SERVICE BULLETIN

Exchange of floats on ROTAX® Engine Type 912 and 914 (Series)

ATA System: 73-00-00 Fuel system

MANDATORY

Fig. 2

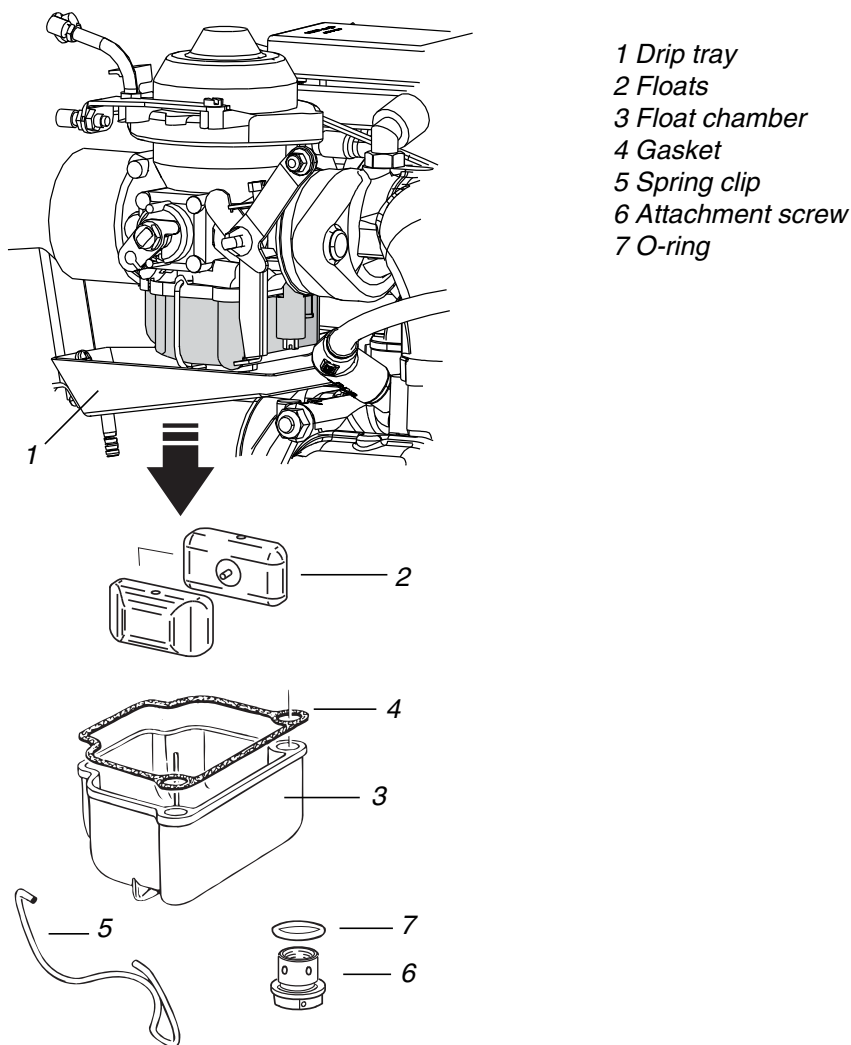
Step	Procedure
1	Remove drip tray (1).
2	Visual inspection of the carburetor and its mechanical actuation.
3	Remove spring clip (5) or for ROTAX 914 Series remove safety wire, loosen cap screw (6) and remove with O-ring (7).
4	Remove float chamber (3), gasket (4) and the two floats (2)

Step	Procedure
1	Remove the gasket (4) from the float chamber and for ROTAX 914 Series exchange the O-ring (7).
2	Install float chamber (3) with gasket (4) and both floats (2).

Step	Procedure
3	Close spring clip (5) or for ROTAX 914 Series install the attachment screw (6) including O-Ring (7) and apply safety wire. Tightening torque of attachment screw 5.5 Nm (48.7 in.lb).
4	Install drip tray (1) and/or accessories according to the instructions of the aircraft manufacturer.
